Project overview

Unite The Heights – 8 Avenue N. Functional Planning Study

Community Report Back: What We Heard

Concept: Existing Conditions with Additional Traffic Calming Measures

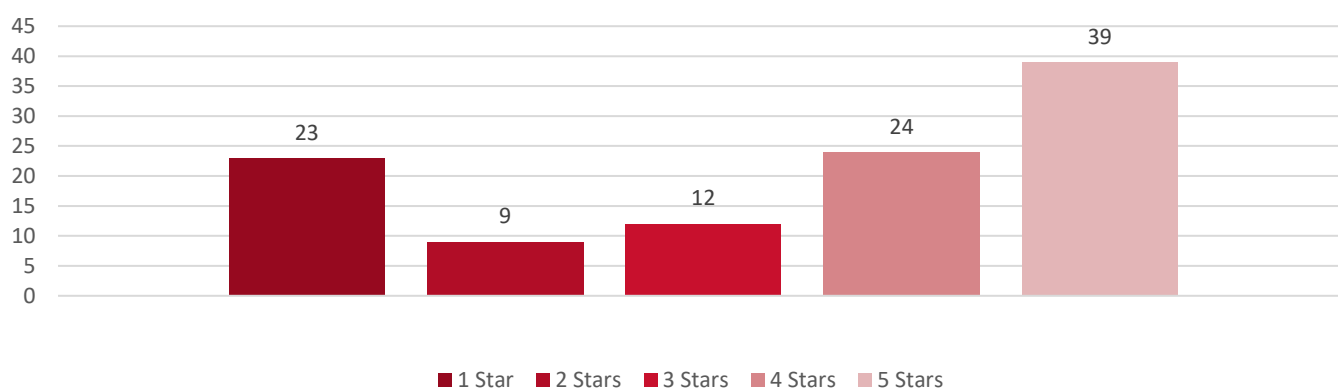
Themes	
Safety	Participants identified safety as a top priority. Some feedback indicated that this concept does not do enough to uphold safety in terms of the traffic calming measures and a desire for physical separation of wheeling users and vehicles. Other feedback indicated this concept does increase the safety for users of the corridor.
Traffic calming	<p>Community feedback indicated the need for traffic calming in the area. Some feedback indicated the proposed improvements provide effective traffic calming, while other feedback was critical that what is being proposed is not enough and provided specific feedback as to which type of traffic calming measures they would like to see on the corridor.</p> <p>Additionally, some feedback indicated that the current traffic calming measures are sufficient and to remain status quo.</p> <p>Feedback was mixed regarding the potential traffic signal at Centre Street N. and new traffic button at 1 Street N.W.</p>

Physical separation for vehicles and active modes	Feedback demonstrated high value in the physical separation of modes and indicated sharing the road with cars and wheeling users is a safety concern.
Support & Opposition	Participant feedback was mixed over the need for these improvements and project in general. Some appreciated these proposed improvements and the project, while others felt it is not necessary and tax dollars should be spent elsewhere.

Concept 1: Multi-Use Pathway on North Side

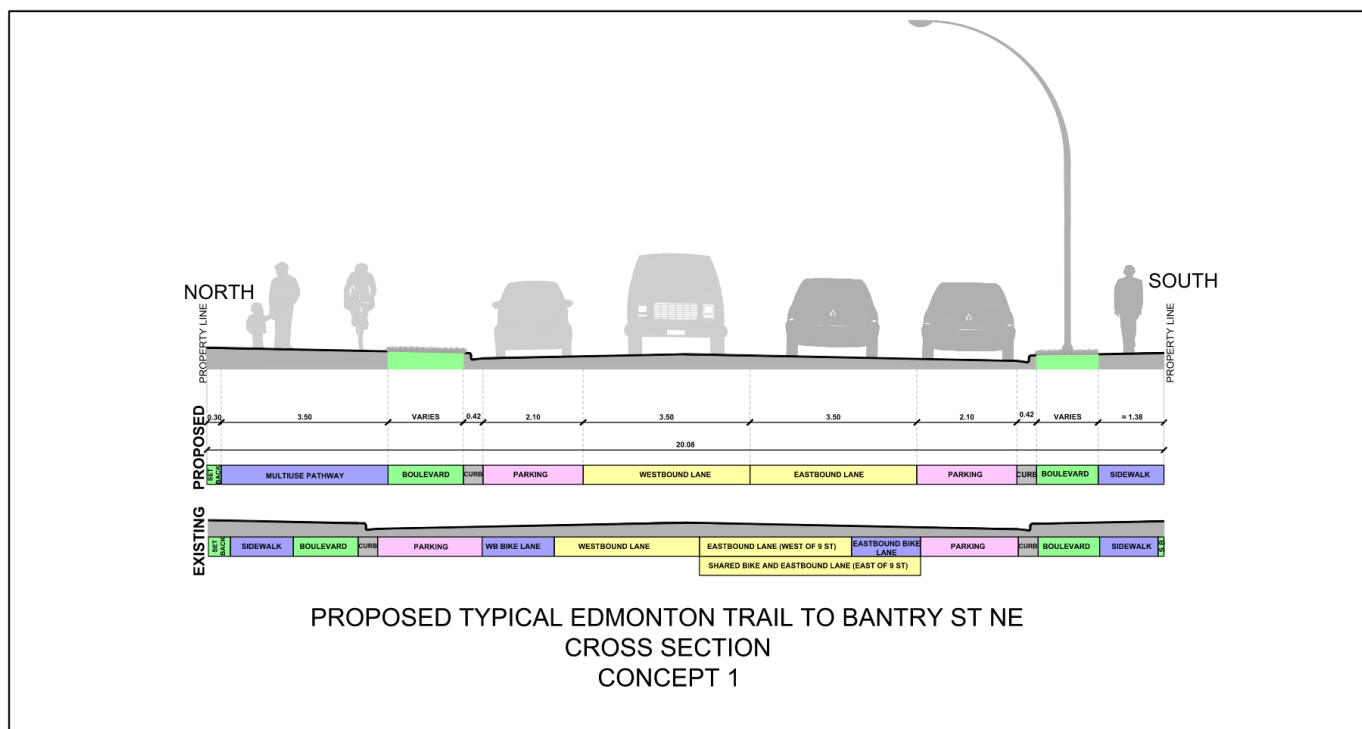
Themes	
Parking	Participants identified parking as a top priority along the corridor. While some feedback indicated that more parking could be removed, most of the feedback was opposed to parking loss.
Safety	Participants identified safety as a high priority. Feedback indicated the concept of a multi-use path presents a risk of conflicts between pedestrians and wheeling users.
Physical separation for pedestrian and wheeling users	Feedback demonstrated high value in the physical separation of modes and expressed concern over the increased risk of wheeling user and pedestrian conflicts on the North side of the path.
Greenery	A desire for trees and greenery was present within the feedback collected.
Intersection crossing	Feedback revealed questions and concerns over how the concept will integrate to the intersection crossings and expressed a desire for efficiency and consistency.
Integrated connections	Participants expressed the importance of integrated connections to adjacent corridors.

Snow clearing	Participants appreciated this concept allows for easy snow removal.

Concept 2: Raised One-Way Wheeling Paths

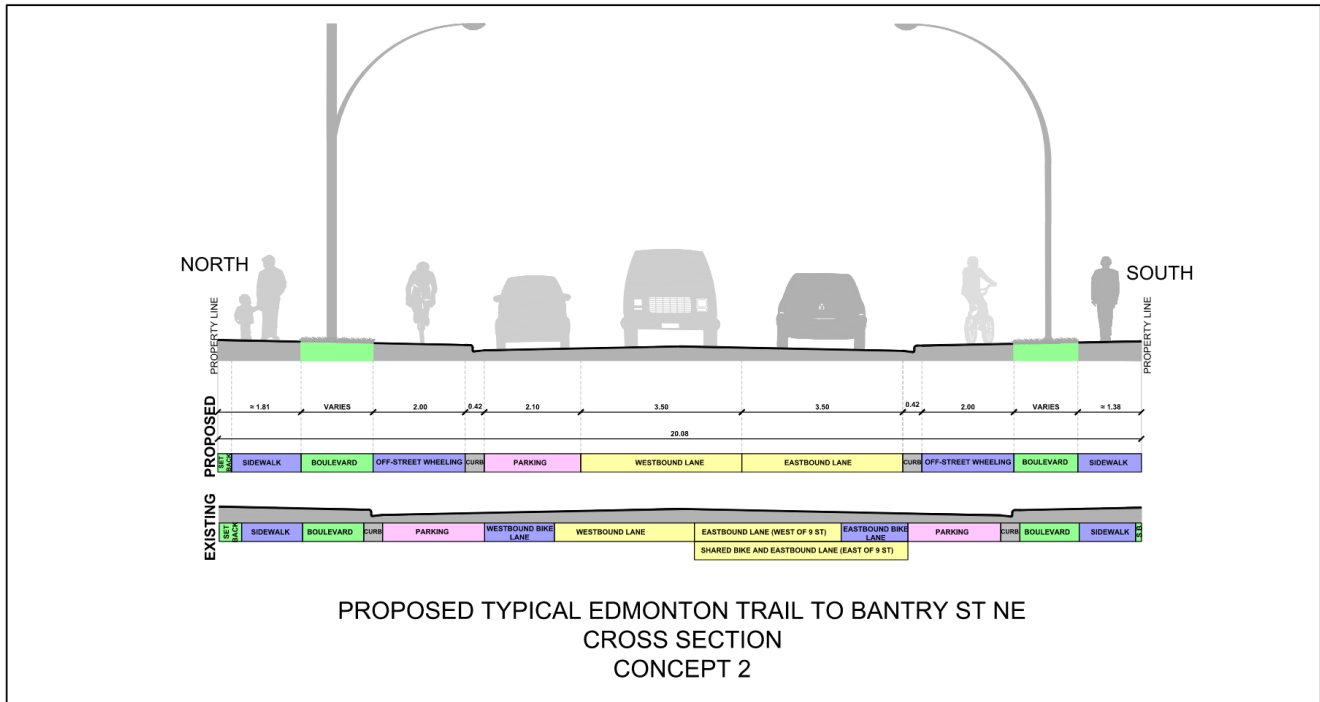
Themes	
Parking	Participants identified parking as a high priority along the corridor and most of the feedback was opposed to parking loss.
Support & Opposition	Participant feedback was mixed over the need for this concept and project in general. Some appreciated these proposed improvements, concept, and the project, while others questioned the wheeling utilization rate and do not support the concept and project.
Safety	Participants identified safety as a top priority. Feedback indicated this concept reduces the risk of conflicts between all modes of transportation.
Cost	Feedback indicated a concern over the high cost of this concept.

Bridge section Concept: Multi-Use Pathway on North Side

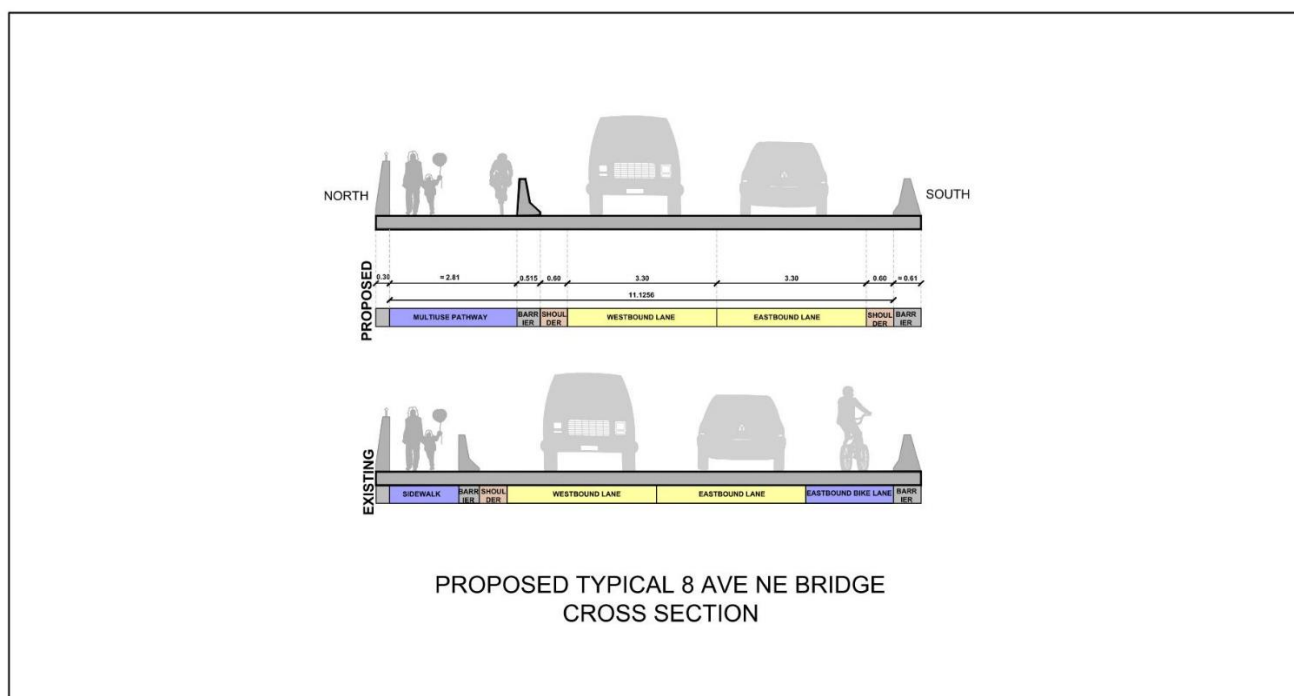
Themes	
Safety	Participants identified safety as a top priority. Feedback indicated this concept presents the risk of conflicts between wheeling users and pedestrians.
General support	Feedback indicated general support for this concept and felt it was a great improvement compared to the current state.
Multi-use Pathway Width	Comments submitted indicate a desire for the multi-use pathway to be wider. Some portions of the feedback felt this extra width could be taken from the driving lanes.
Continuous treatment, transitions, and criss-crossing	Participant feedback expressed a concern of how each segment treatment would transition from one to the other and expressed concern over criss-crossing. A desire for continuous, efficient, and safe movement across the corridor was expressed.
Integrated connections	Participants expressed the importance of integrated connections to adjacent corridors.

16a Street N.E. to 19 Street N.E. Cross Section concept

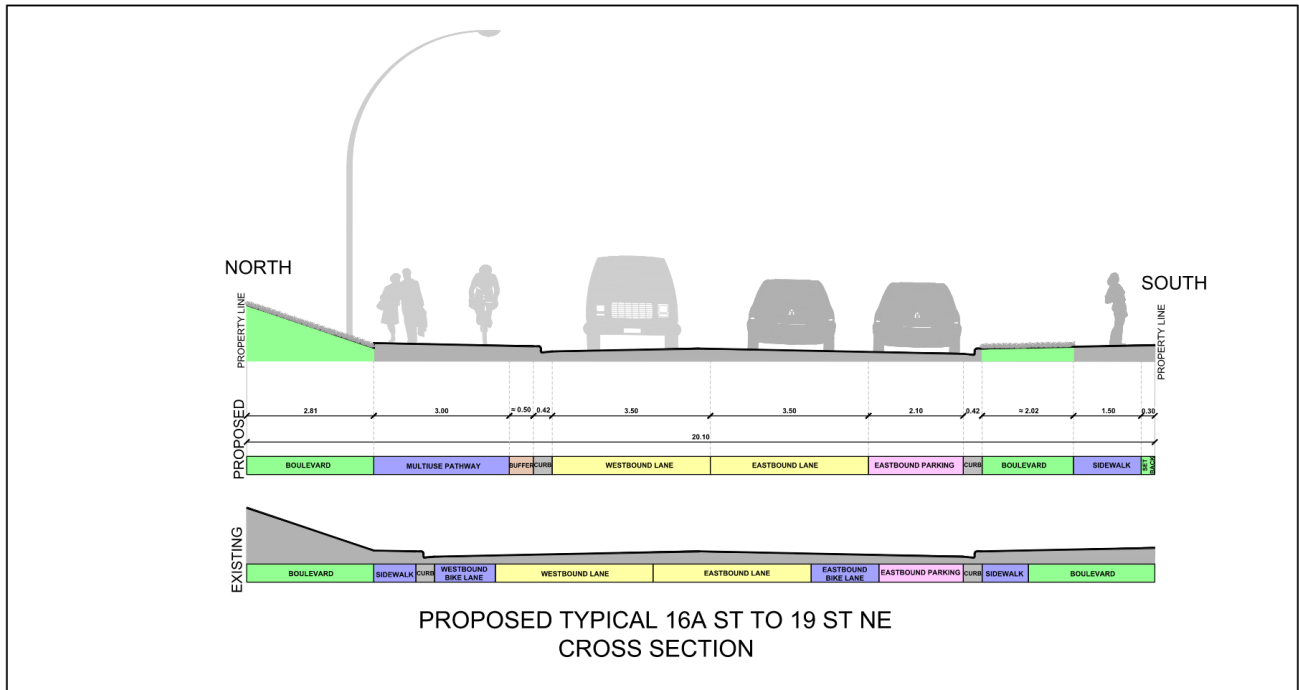
Themes	
Safety	Participants identified safety as a top priority. Feedback indicated this concept presents the risk of conflicts between wheeling users and pedestrians within this concept. Additionally, comments felt that cyclists should not be travelling in opposing directions on the same multi-use pathway as that poses the risk of conflict.
Continuous treatment, transitions, and criss-crossing	Participant feedback expressed a concern of how each segment treatment would transition from one to the other and expressed concern over criss-crossing. A desire for continuous, efficient, and safe movement across the corridor was expressed.
Multi-use Pathway Width	Comments submitted indicate a desire for the multi-use pathway to be wider. Some portions of the feedback felt this extra width could be taken from the driving lanes.
General support	Feedback indicated general support for this concept and felt it was a great improvement compared to the current state.

Concept 1: Multi-Use Pathway on North Side

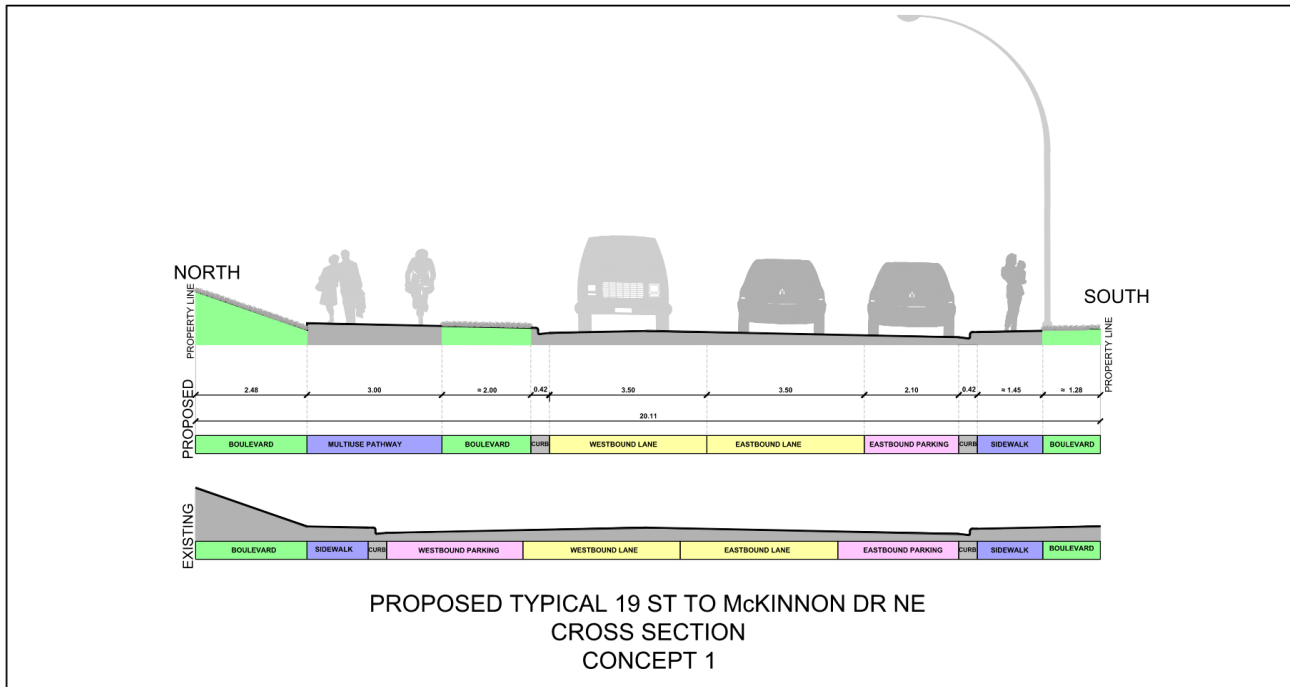
Themes	
Parking	Participants identified parking as a high priority along the corridor and most of the feedback was opposed to parking loss.
Safety	Participants identified safety as a top priority. Feedback indicated this concept presents the risk of conflicts between wheeling users and pedestrians on the North side.
Lack of support	Feedback indicated a lack of support for the concept and the project. Comments received questioned the future need and current utilization rate of active modes along the corridor.
Continuous treatment, transitions, and criss-crossing	Participant feedback expressed a concern of how each segment treatment would transition from one to the other and expressed concern over criss-crossing. A desire for continuous, efficient, and safe movement across the corridor was expressed.
Multi-use pathway location	Comments submitted indicate a desire for relocating the multi-use pathway from the North to the South side of the corridor.

Integrated connections	Participants expressed the importance of integrated connections to adjacent corridors.

Concept 2: Two On-Street One-Way Wheeling Lanes on North and South Sides with Concrete Curbs as Buffers

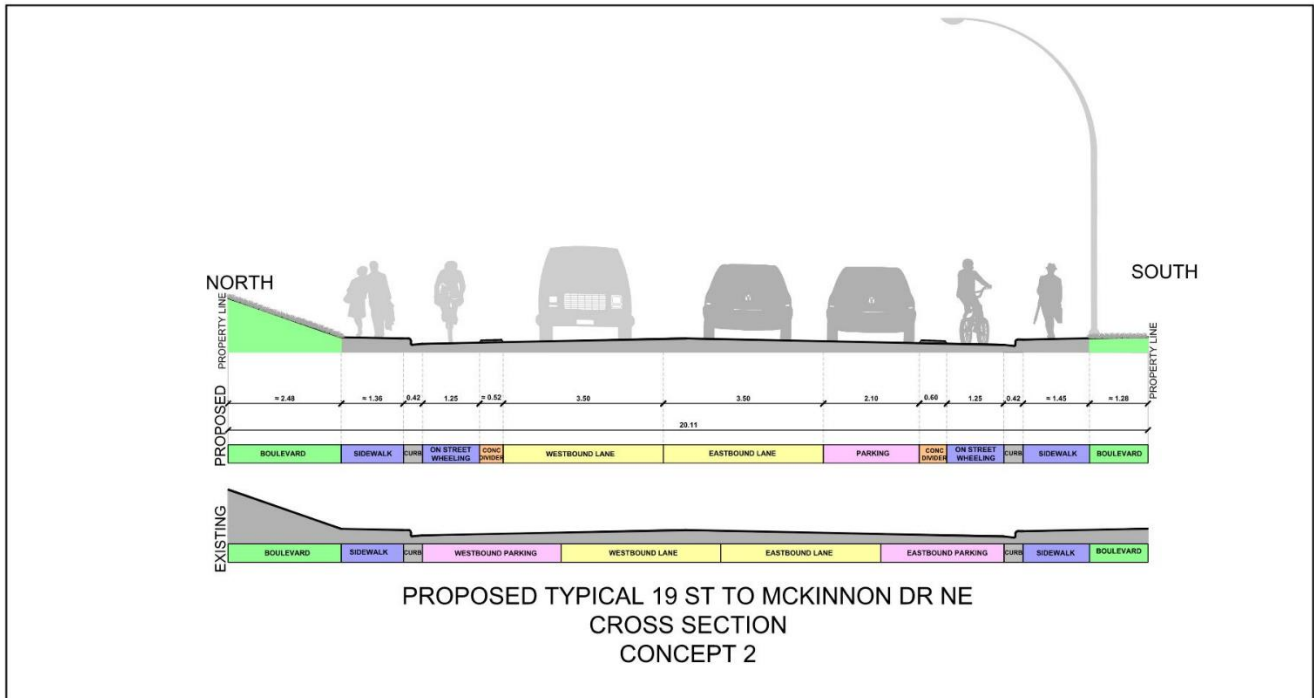
Themes	
Parking	Participants identified parking as a high priority along the corridor and most of the feedback was opposed to parking loss.
Lack of support	Feedback indicated a lack of support for the concept and the project. Comments received questioned the future need and current utilization rate of active modes along the corridor. These comments expressed a desire for the status quo.
Safety	Participants identified safety as a top priority. Feedback indicated this concept presents the risk of conflicts at intersections between wheeling users and pedestrians. Comments acknowledged the concept's proximity to nearby schools and how this project needs to ensure safe integration into their infrastructure by keeping in mind student pick up/drop off and students cycling to school.
Wheeling lane width	Comments submitted indicate a desire for the wheeling lane to be wider.

Snow removal	Concerns were express with snow removal as it relates to this concept.
--------------	--

Concept: Multi-Use Pathway on West Side

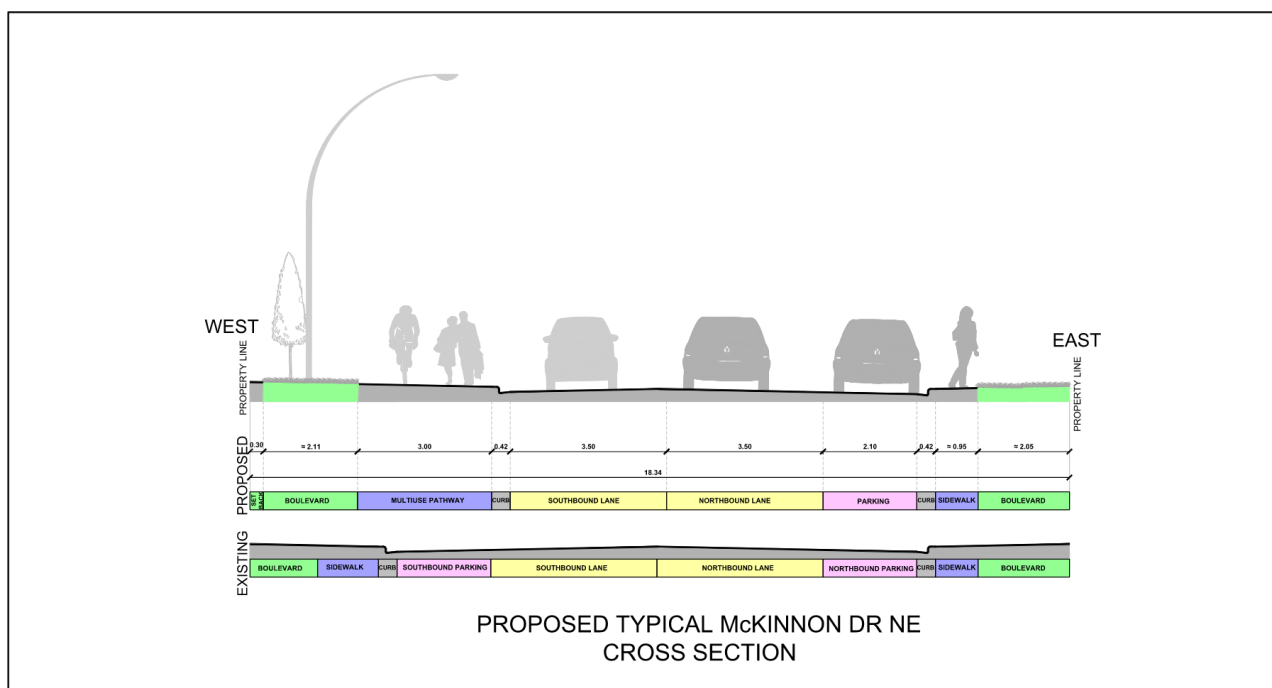
Themes	
Lack of support	Feedback indicated a lack of support for the concept and the project. Comments received questioned the future need and current utilization rate of active modes along the corridor.
Parking	Participants identified parking as a high priority along the corridor and most of the feedback was opposed to parking loss.
Safety	Participants identified safety as a top priority. Feedback indicated this concept presents the risk of conflicts between wheeling users and pedestrians on the multi-use pathway.

Concept 1: Multi-Use Pathway on South Side

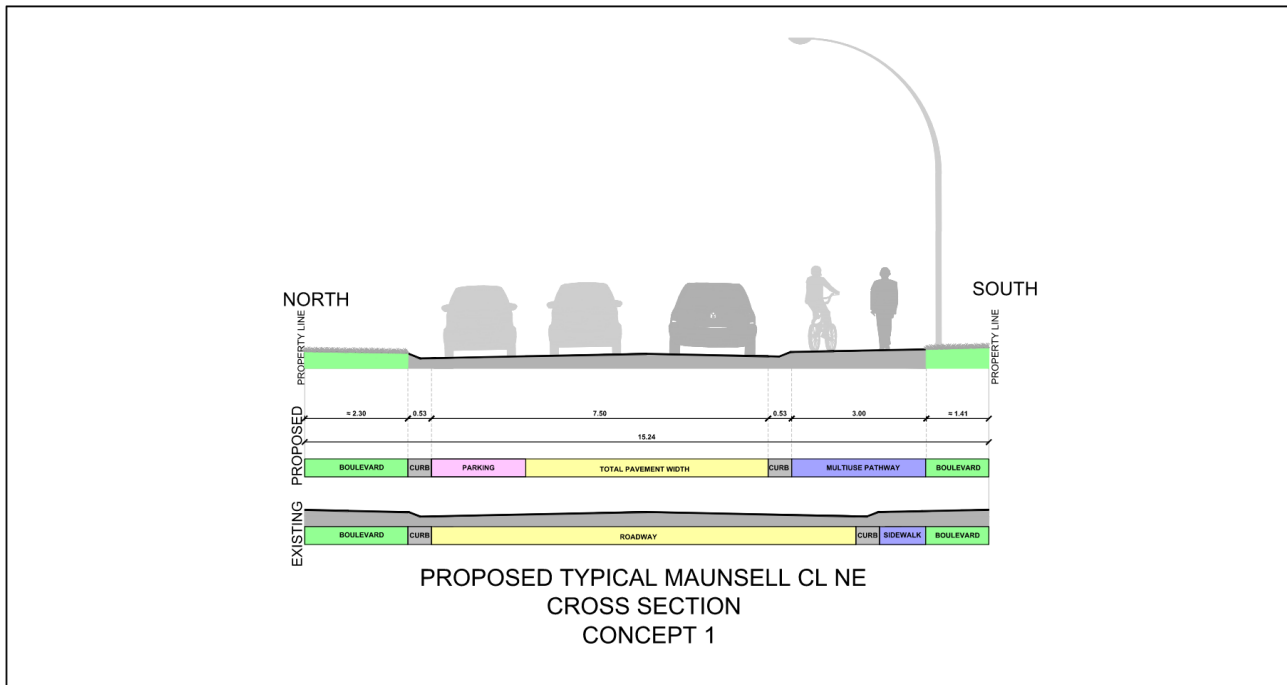
Themes	
Lack of support	Feedback indicated a lack of support for the concept and the project.
Parking	Participants identified parking as a high priority along the corridor and most of the feedback was opposed to parking loss.
Multi-use pathway location	Feedback suggested a movement of the multi-use pathway from the South to the North side.
Safety	Participants identified safety as a top priority. Feedback indicated this concept presents the risk of conflicts between wheeling users and pedestrians on the multi-use pathway.
Integrated connections	Participants expressed the importance of integrated connections to adjacent corridors.
Support	Feedback indicated support for the concept and the project.

Concept 2: Shared On-Street Wheeling Route

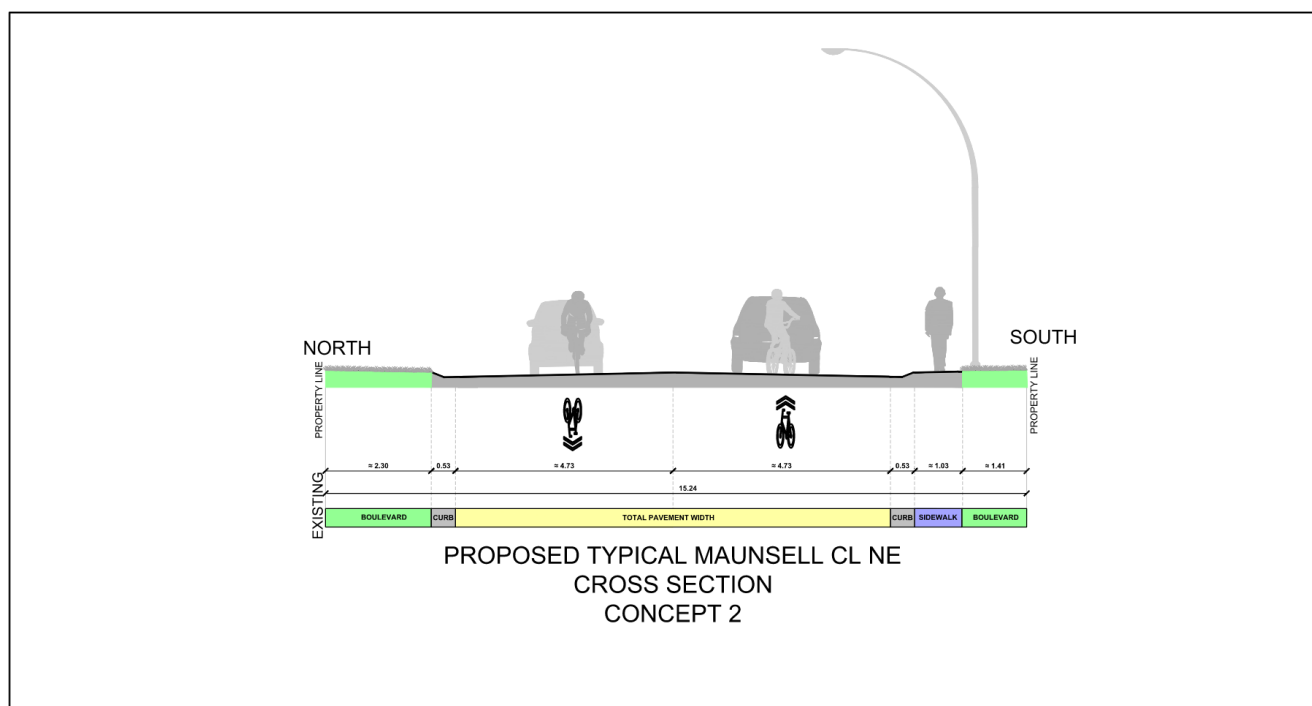
Themes	
Lack of support	Feedback indicated a lack of support for the concept and the project.
Safety	Participants identified safety as a top priority. Feedback indicated this concept presents the risk of conflicts between wheeling users and vehicles.
Lack of significant improvement	Participants didn't feel this concept is a significant improvement from the status quo.
